CITY OF LOS ANGELES
INTER-DEPARTMENTAL MEMORANDUM

1600 S Flower Street/426 & 440 W Venice Bl
LADOT Case #CEN18-47190

Date: January 6, 2020

Subject: **UPDATED TRANSPORTATION IMPACT ANALYSIS FOR THE PROPOSED SOUTH PARK TOWERS MIXED-USE PROJECT AT 1600 SOUTH FLOWER STREET/426 AND 440 WEST VENICE BOULEVARD (ENV-2018-3337-EAF/VTT-82213)**

Figure D.2
17th Street & Grand Avenue
Improvement Concept Plan

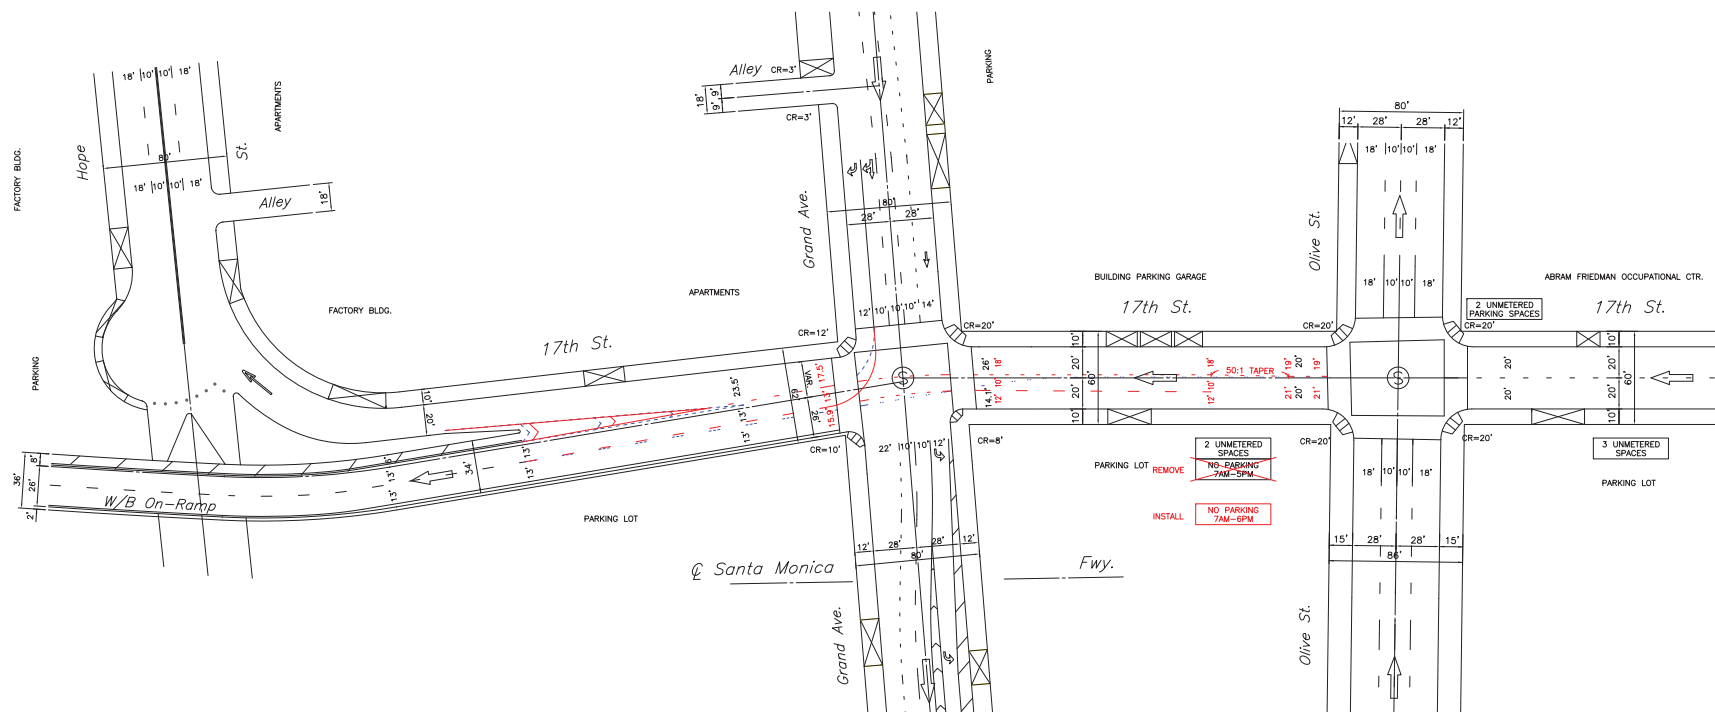
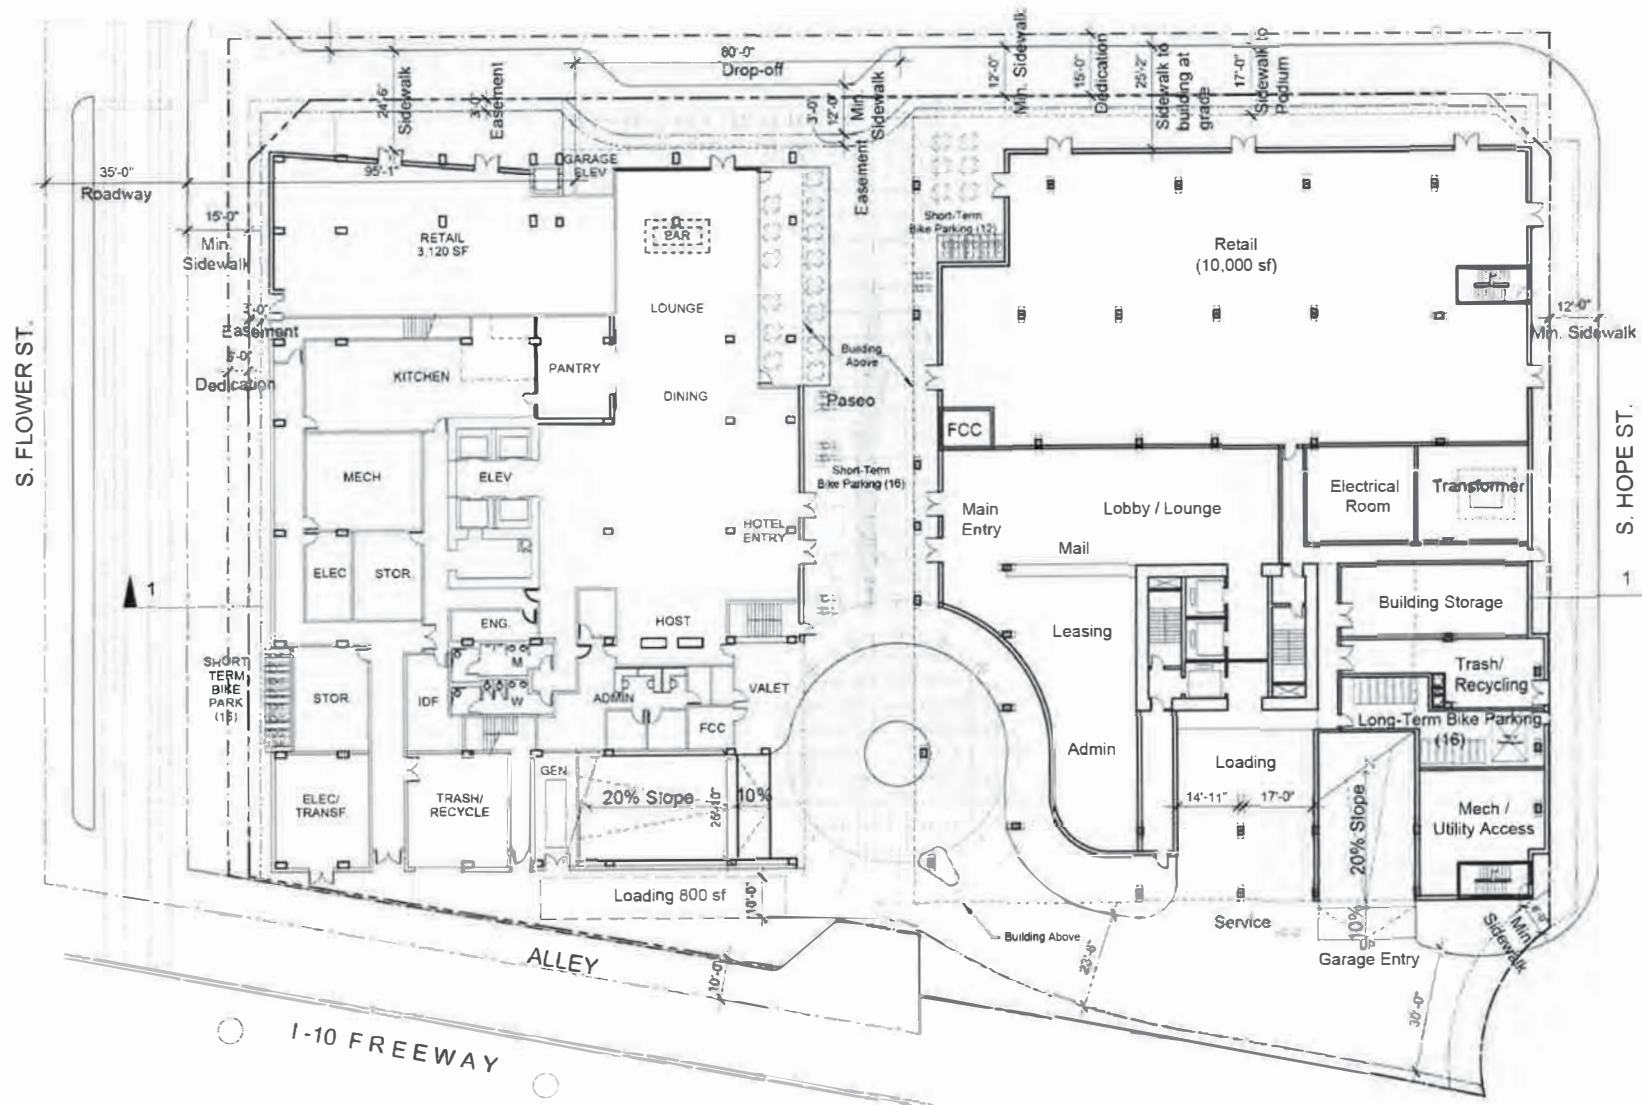
The project proposes to restripe the westbound approach of 17th Street within the existing roadway width to accommodate one shared through/left-turn lane and two through lanes on 17th Street as illustrated in **Attachment 4**. This would require the removal of approximately two unmetered parking spaces on 17th Street.

The applicant should be responsible for the cost and implementation of any necessary traffic signal equipment modifications, bus stop relocations and lost parking meter revenues associated with the proposed transportation improvement described above. All proposed street improvement and associated traffic signal work within the City of Los Angeles must be guaranteed through BOE's B-Permit process, prior to the issuance of any building permit and completed prior to the issuance of any certificate of occupancy. Prior to setting the bond amount, BOE shall require that the developer's engineer or contractor contact DOT's B-Permit Coordinator, at (213) 972-8687, to arrange a pre-design meeting to finalize the proposed design. Costs related to any relocation of bus zones and shelters, to modifying or upgrading traffic signal equipment, and that are necessary in order to implement the proposed mitigations shall be incurred by the applicant.

If a proposed traffic mitigation measure does not receive the required approval during plan review, a substitute mitigation measure may be provided subject to the approval of LADOT or other governing agency with jurisdiction over the mitigation location, upon demonstration that the substitute measure is environmentally equivalent or superior to the original measure in mitigating the project's significant traffic impact. To the extent that a mitigation measure proves to be infeasible and no substitute mitigation is available, then a significant traffic impact would remain.
